PCN – Process Change Notification

Change:	AP.10F.07.0039B
Date:	2018/08/03
Author	Rachel Wu

Model#	Part Number	Changes
AP.10F 2 Stage 25dB Antenna 39mm 0.81 IPEX MHF1	AP.10F.07.0039B	<ol style="list-style-type: none"> 1. Change the appearance color. 2. Delete cable dimensions. 3. Modify the tolerance & BOM.

Illustration of Change Old Drawing

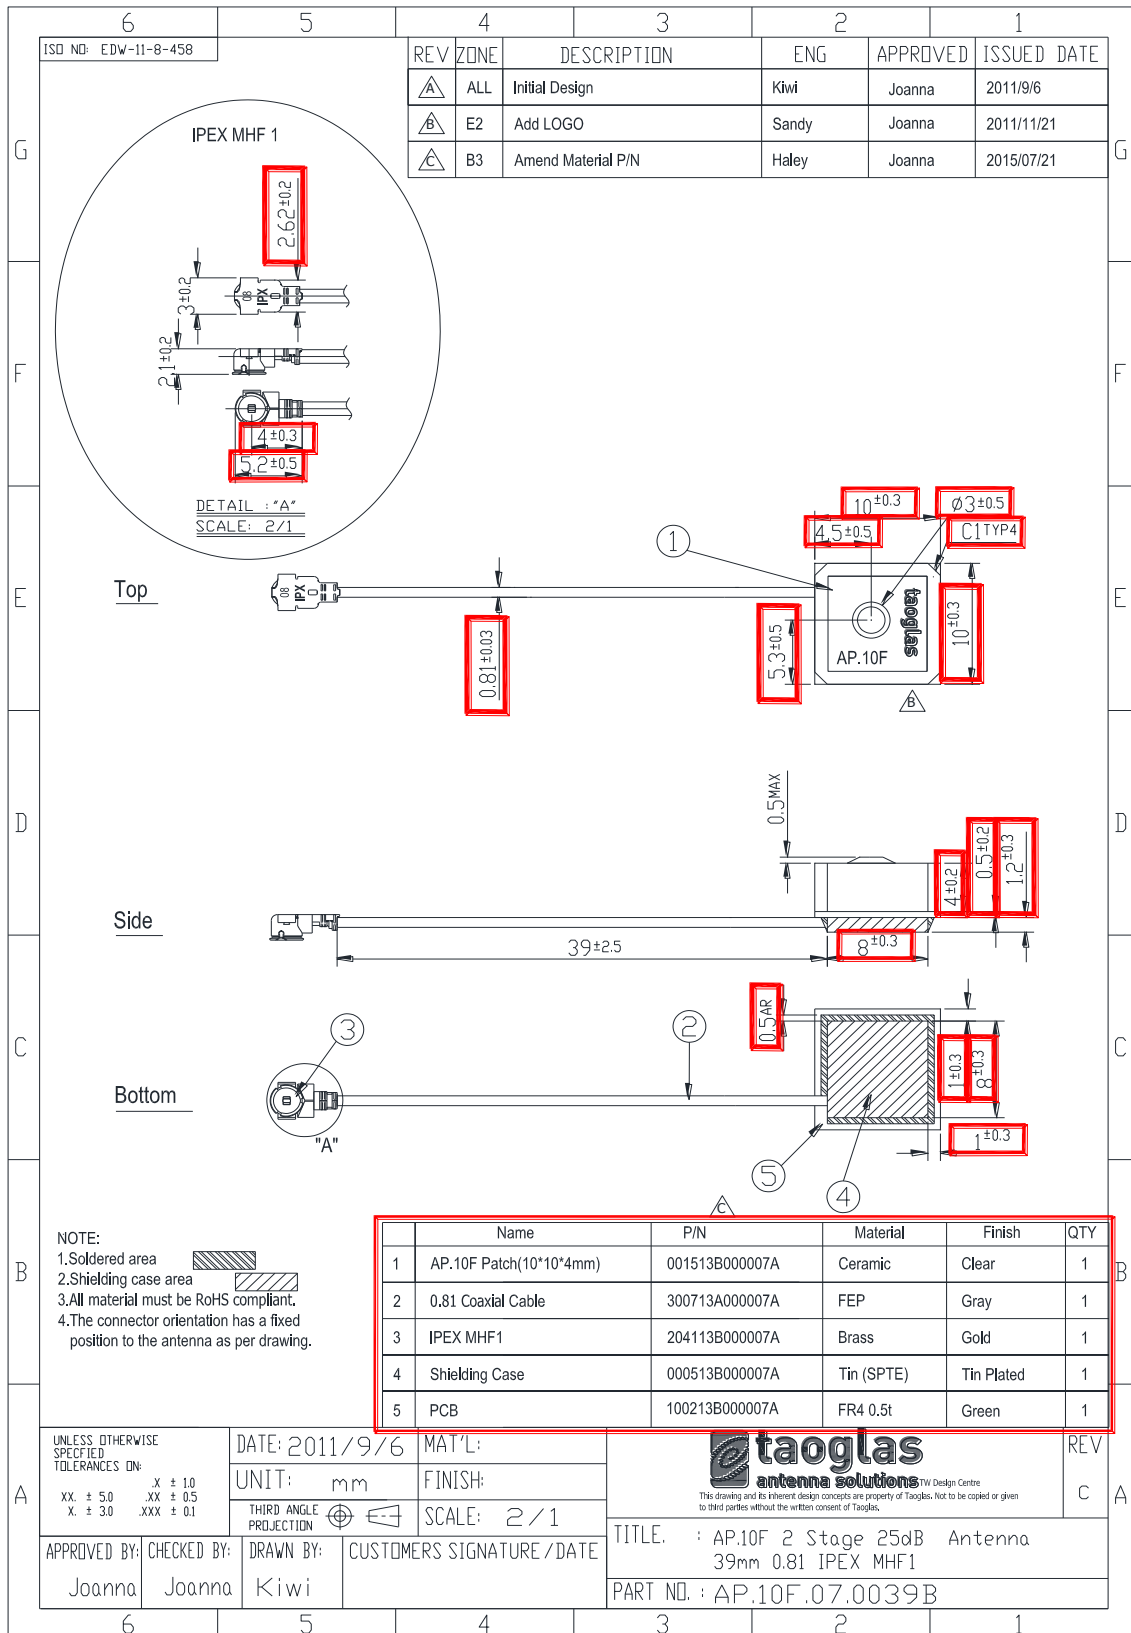
1. Change the appearance color. (Violet->Brown)
2. Delete cable dimensions.
3. Modify the tolerance ($\pm 0.3 \rightarrow \pm 0.2$) & BOM.
